**Application for the Proposed  
Victoria Station Upgrade**

**Victoria Palace Theatre  
OBJ21/P7**

**Proof of Evidence  
Mr Paul Speirs**

**Figure 3.1 – LUL's Preferred Layout - Plan**

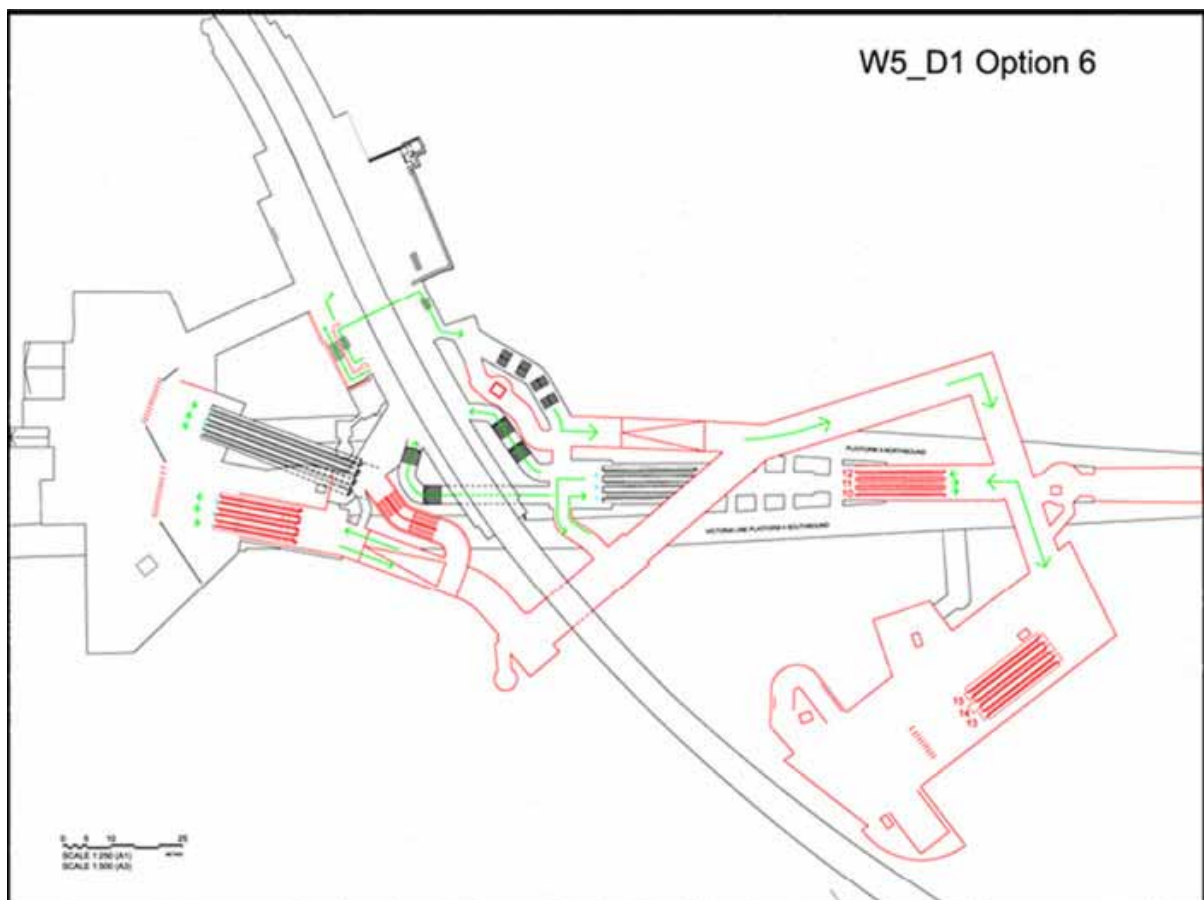
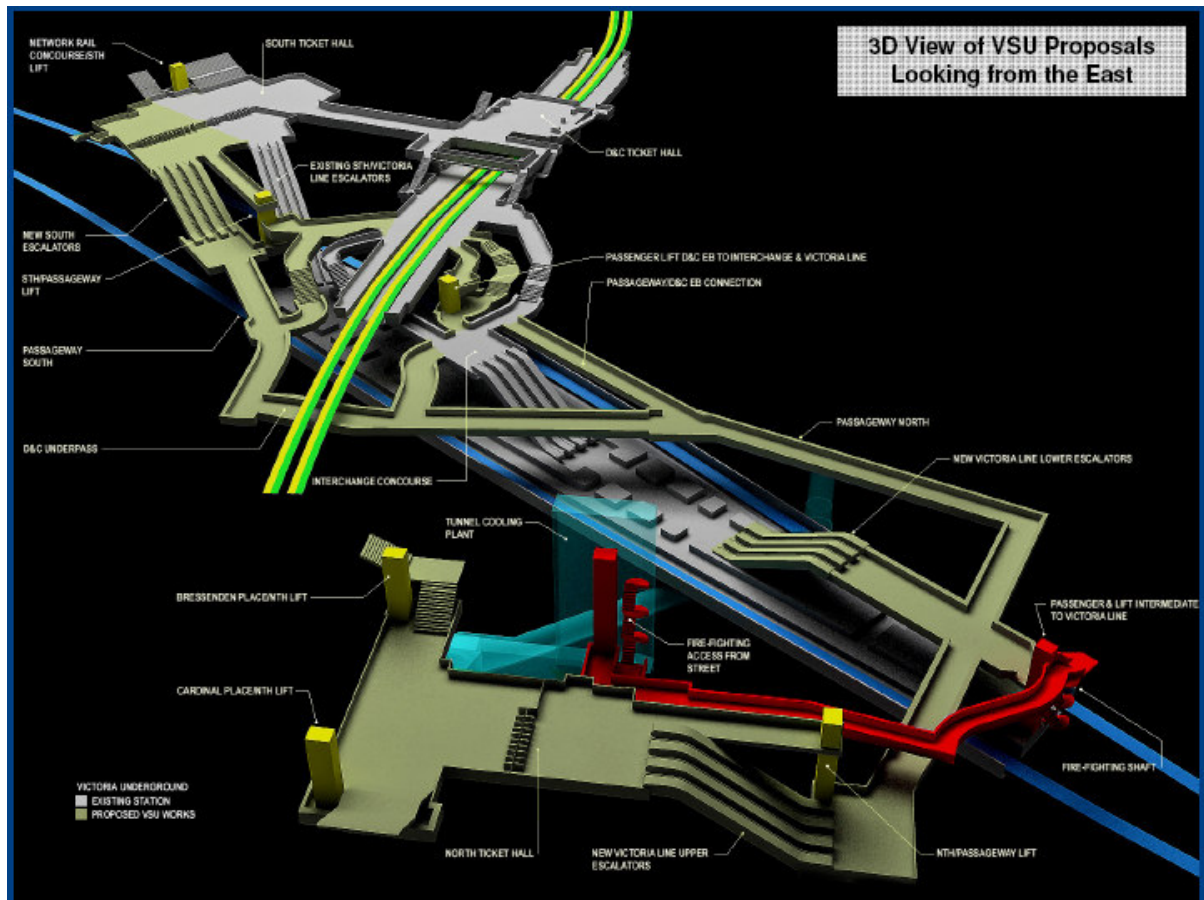
3.6.12 The statement implies that all interchange movements from the D&C to the Victoria Line will use the new west link and not the existing interchange concourse. Technical Appendix C, Option 6 VSU.A31 also states that

3.6.13 These two statements imply that a one way system is in place with the western PAL linking the D&C to the Victoria Line and the existing interchange concourse linking the Victoria Line to the D&C.

**Figure 3.3 – Passenger Densities Scheme Layout 2016: 0845-0900 hrs (Figure 10b)**

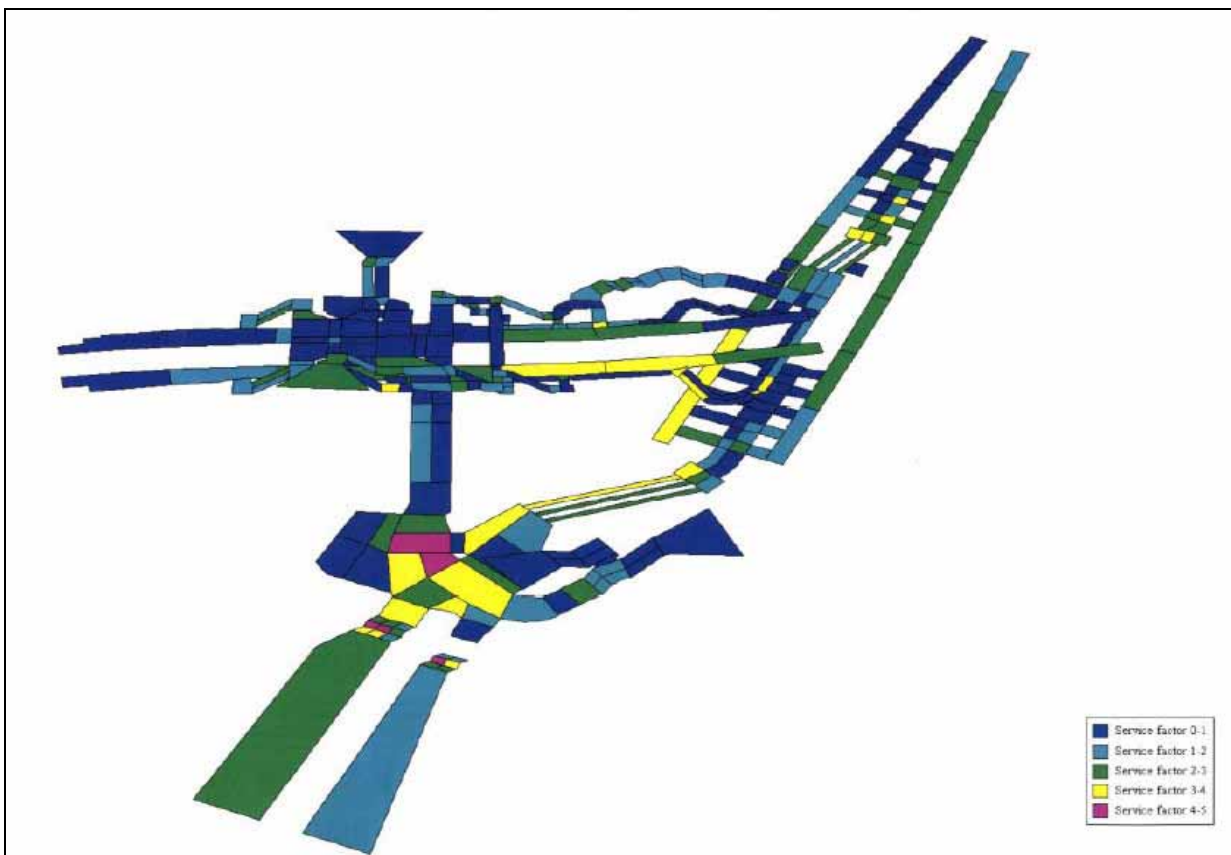
3.7.4 The images are taken from a PEDROUTE analysis of the station. Figure 10b shows the densities as forecast in 2016 and Figure 11b shows the densities under the proposed scheme. PEDROUTE is a bespoke pedestrian modelling software traditionally used by London Underground to assess the levels of service in their stations. The station is assessed by breaking the station elements down into small blocks where the pedestrian activity and hence density can be measured. The level of service is shown in the colour coded format as used by LUL below.

3.7.5 In Figure 10b the worst Level of Service forecast for 2016, shown in red, is at the top of the STH escalators. The second worst Level of Service, shown in yellow, is frequently forecast throughout the station including:

3.7.7 The core objective was to address the congestion on the platform. Comparing the densities of the platforms with and without the proposal sheds some light on the success of the proposal.

**Figure 3.4 – Passenger Densities Scheme Layout 2016: 0845-0900 hrs (Figure 11b)**

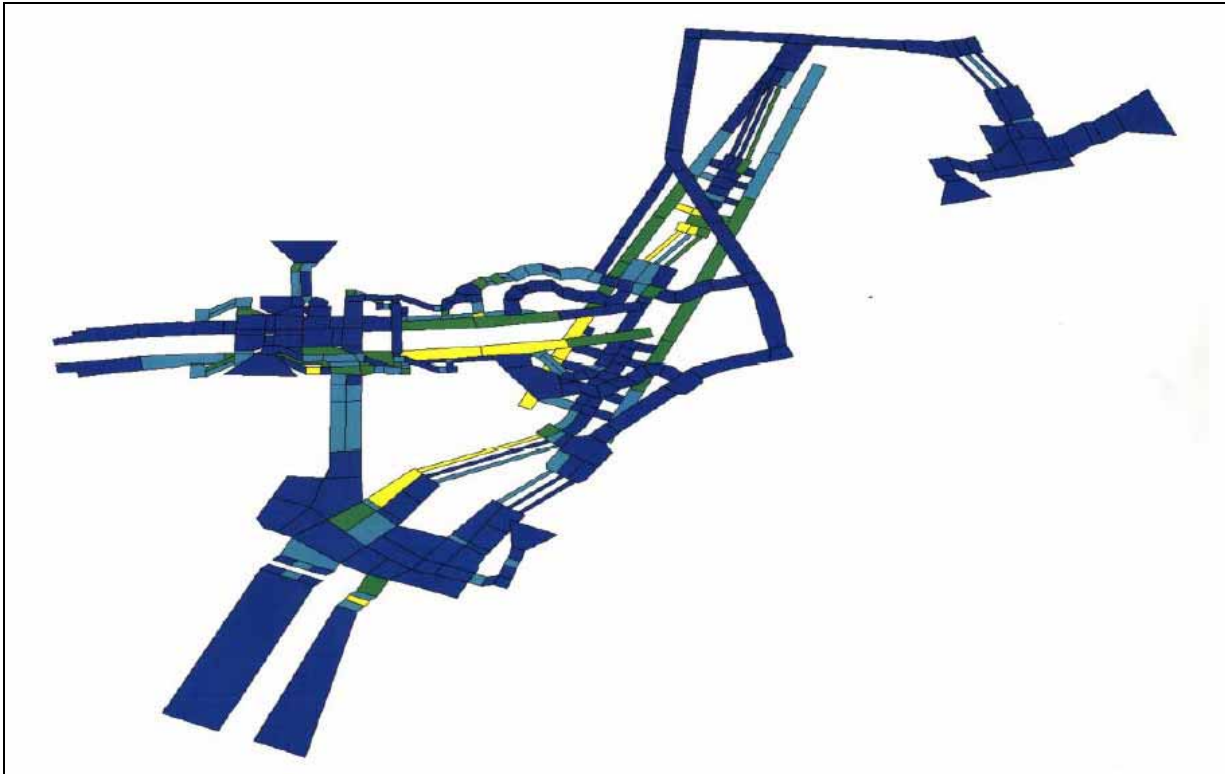
3.7.6 In Figure 11b there are no red areas, i.e. the worst Level of Service is not experienced. However there are still pockets of yellow:

- The existing STH down escalator
- The eastern end of the WB D&C platform
- The southern end of the NB Victoria Line platform
- The interchange down escalator

**Existing 2016**

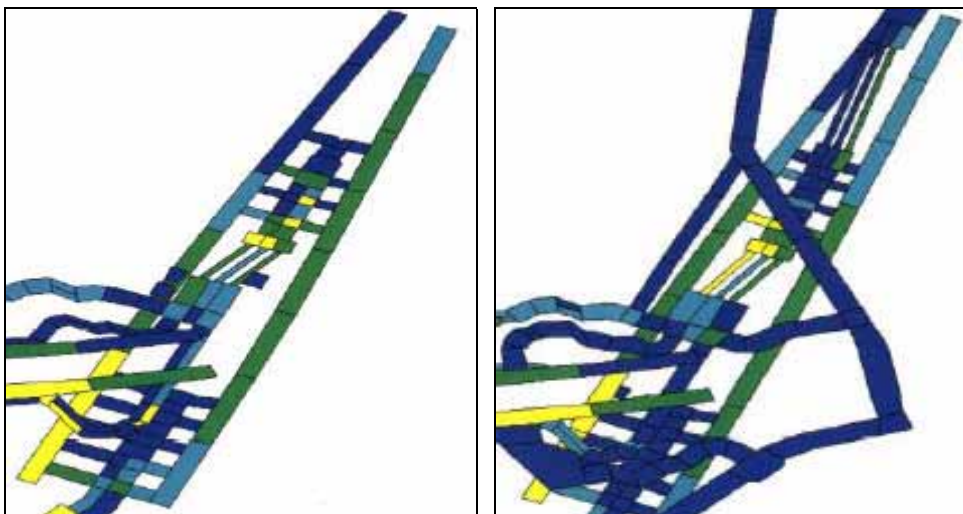
3.7.8 In both instances the density at the southern end of the NB Victoria Line platform remains in the same Level of Service band (yellow). The central section of the NB platform is also denser with the proposal. The density on the interchange down escalator is worsened under the proposal.

3.7.9 The images above do not demonstrate that the core objective of freeing up platform capacity has worked as congestion at the southern end of the NB platform still remains. One could venture by saying that the platform capacity is dictated by the quality of the train services rather than the platform access/egress

Figure 5.1 – LUL Routing Decisions & Triggers

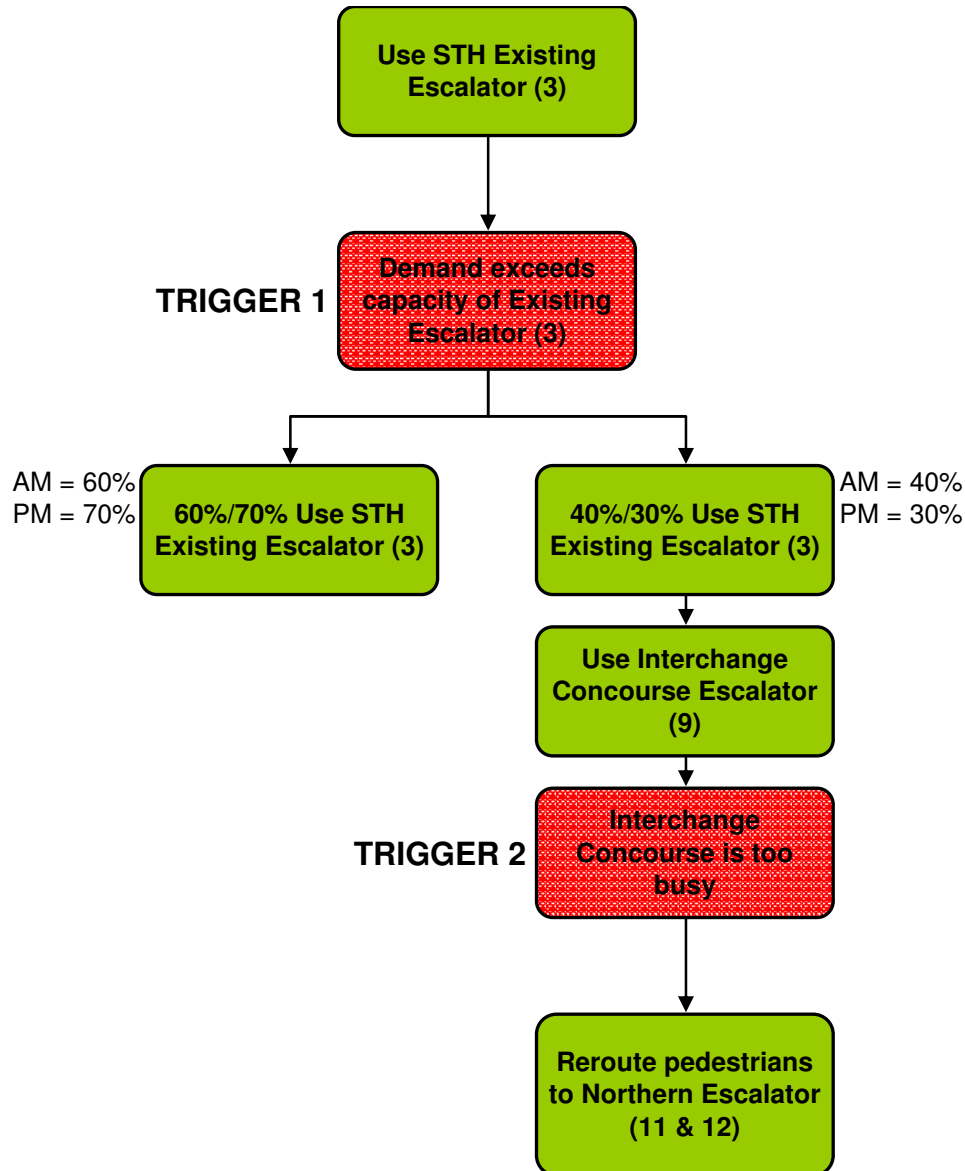
- 5.6.5 These splits appear arbitrary.

5.6.7 To put this regime to the test I have calculated the peak minute demand from the STH to the VL starting from free flow conditions at the existing escalator. Following the regime and the trigger points the escalator demand throughout can be seen. The AM peak analysis is presented below.

5.6.8 Under free flow conditions the demand for the existing escalator is exceeded (170 pedestrians). This calls in Trigger 1; so the STH to VL demand is split 60/40 between the existing and new escalators. The demand for these two down escalators is now within the escalator capacity.

5.6.9 With Trigger 1 kicking in additional demand is sent to the interchange concourse and escalator 6. This adds to the interchanging passengers already using this escalator and at this point the escalator demand exceeds the capacity, so Trigger 2 kicks in. The demand rerouted from escalator 3 after Trigger 1 is now rerouted a second time to the northern escalators to join the NTH to VL pedestrians. This combined demand (78 pedestrians) is within the capacity of one escalator.

5.6.10 **Therefore, in the AM peak, only one down escalator is required at the northern end of the Victoria Line platform. LUL are proposing two.**
